July 19, 2000

**RE: Conditional Approval of GE's Proposal to Address the Presence of DNAPL in Cell G1
Upper 1/2-Mile Reach Removal Action
General Electric-Housatonic River Site, Pittsfield, Massachusetts**

**CELL G1 DNAPL AREA
PROPOSED ACTIVITIES**

FIGURE
6

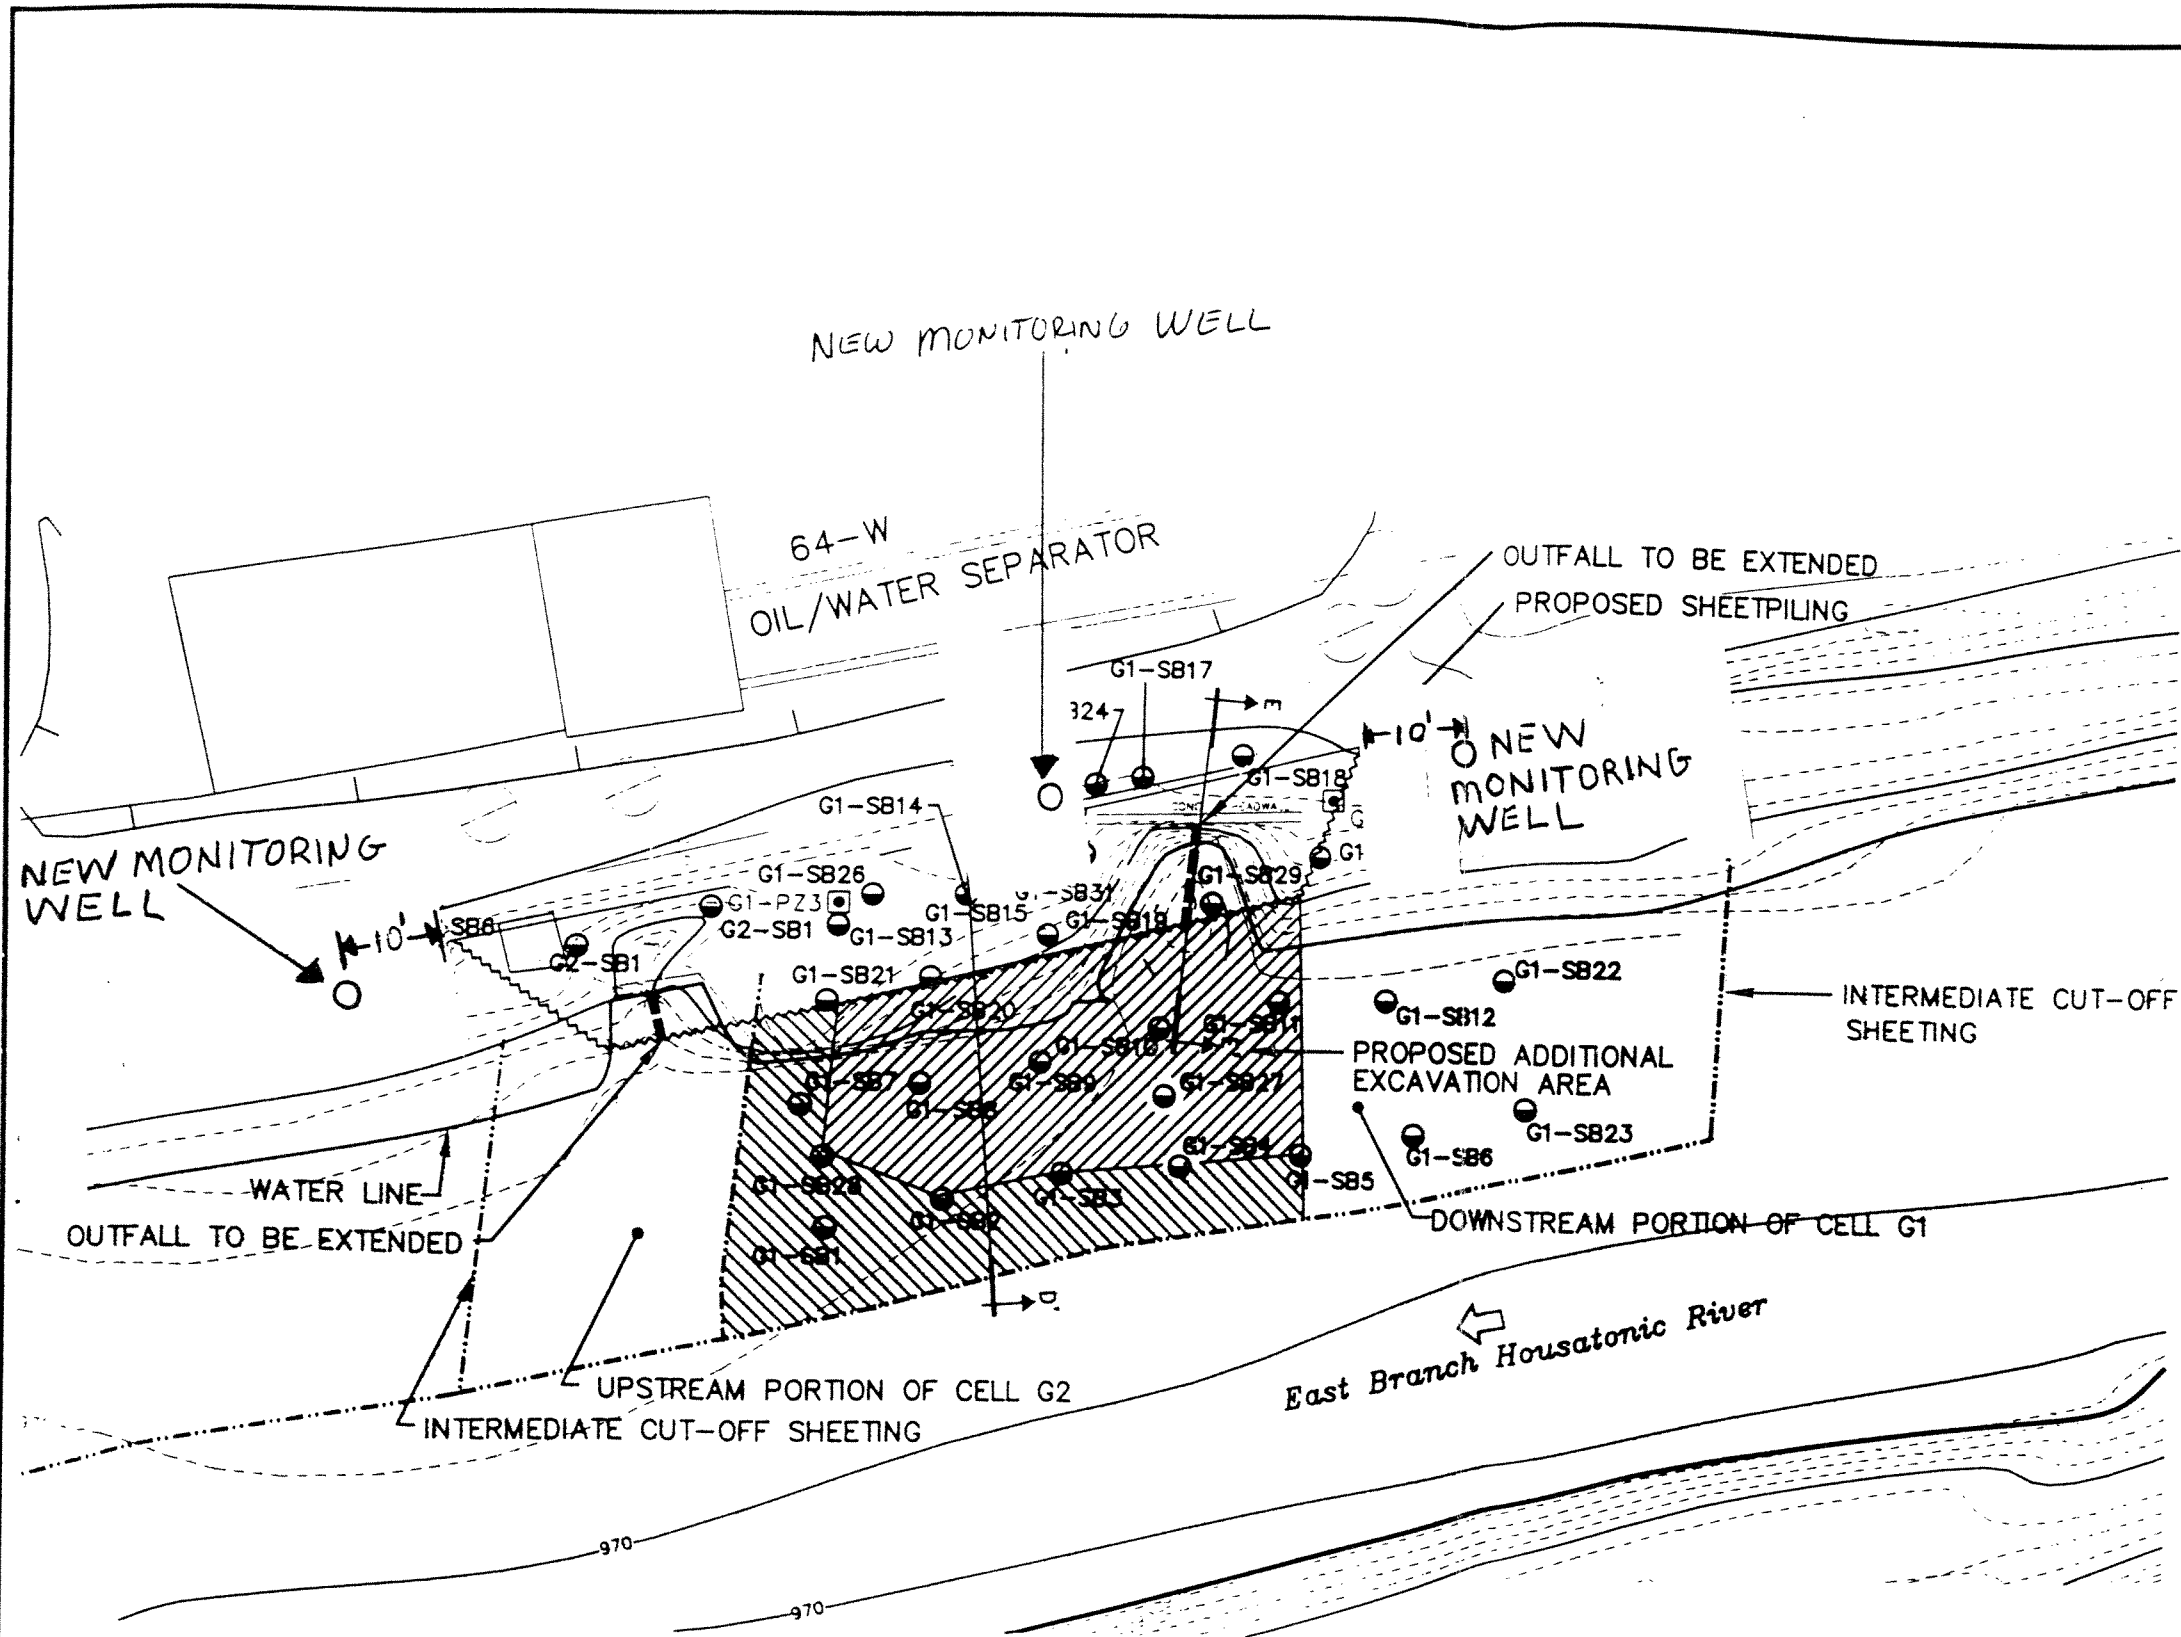
4. Page Section 3, Section IV of the Report states that "A portion of this area will also be excavated further to an elevation of 965." The area to be excavated to elevation 965 is not clearly identified on any of the Figures. Pursuant to discussions with Bill Horne, GE, this is the area described on Figure 6 as the "proposed additional excavation area to a maximum elevation of 963' based on visual observations".

7. GE shall install three monitoring wells as shown on the attached Figure. The two perimeter wells shall be advanced to approximately 963 feet AMSL and the screens shall extend from approximately 963 feet AMSL to 973 feet AMSL. The center well shall be advanced to the top of till and shall be screened from the top of till to approximately 973 feet AMSL. GE shall initially monitor the perimeter wells on a weekly basis to confirm that DNAPL is not present outside the limits of the containment barrier. GE shall also monitor the center well for the presence of DNAPL and shall assess and propose whether or not additional investigative or response actions are required. The timing of the well installation shall be coordinated with the proposed DNAPL response actions in order to prevent the well installation from adversely affecting the sheetpile sealant/grout.
